Before the
FEDERAL COMMUNICATIONS COMMISSION
Washington, D.C. 20554

RM-6147

PETITION OF THE AMERITECH OPERATING COMPANIES
FOR RULEMAKING

PROPOSED REVISIONS
TO
PART 68
FOR TERMINAL EQUIPMENT CONNECTED TO
PUBLIC SWITCHED DIGITAL
SERVICE
(PSDS)

Fig. 68.3 () **SIMULATOR CIRCUIT FOR PSDS
IN ANALOG MODE**

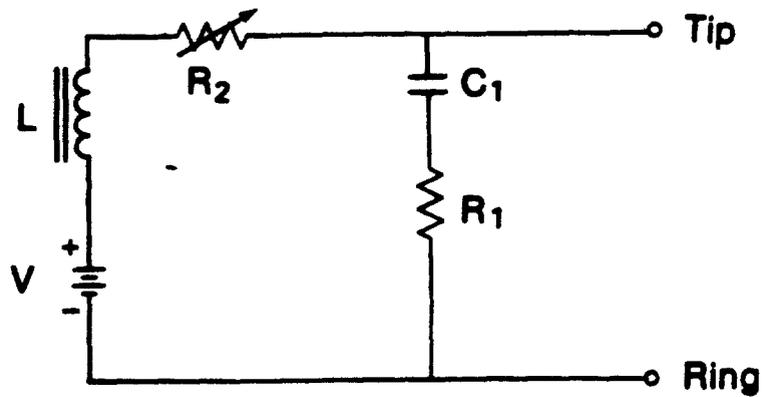
1 PSDS Loop Simulator Circuit: A circuit simulating the
1 network side of the 2-wire telephone connection that is
1 used for testing terminal equipment to be connected to PSDS.
1 Figure 68.3 (m) shows the type of circuit required. Other
1 implementations may be used provided that the same dc voltage
1 and current characteristics and ac impedance characteristics
(new) will be presented to the equipment under test as are
1 presented in the illustrated circuit. When used, the
1 simulator should be operated over the entire range of loop
1 resistances, and with the indicated voltage limits and
1 polarities. Whenever the loop current is changed,
1 sufficient time shall be allowed for the current to reach
1 a steady-state condition before continuing testing.

Terminal equipment must be tested in the analog mode of operation, as indicated in Figure 68.3 (m). The proposed Figure 68.3 (m) is illustrative of the type of circuit which must be employed for the analog mode. However, other implementation may be provided as long as the voltage, current and impedance characteristics are the same. The digital mode does not require a loop simulator since the signal power template provided in Subsection 68.308(h)(3)(ii) provides the necessary protection.

$L \geq 10H$ (Resistance = R_L)

$R_1 = 600 \Omega \pm 1\%$

$C_1 = 500 \mu F, -10\%, +50\%$

V (Volts)		$R_2 + R_L$ (Ohms)
Min	Max	Continuously Variable
36	46	610 To 1510
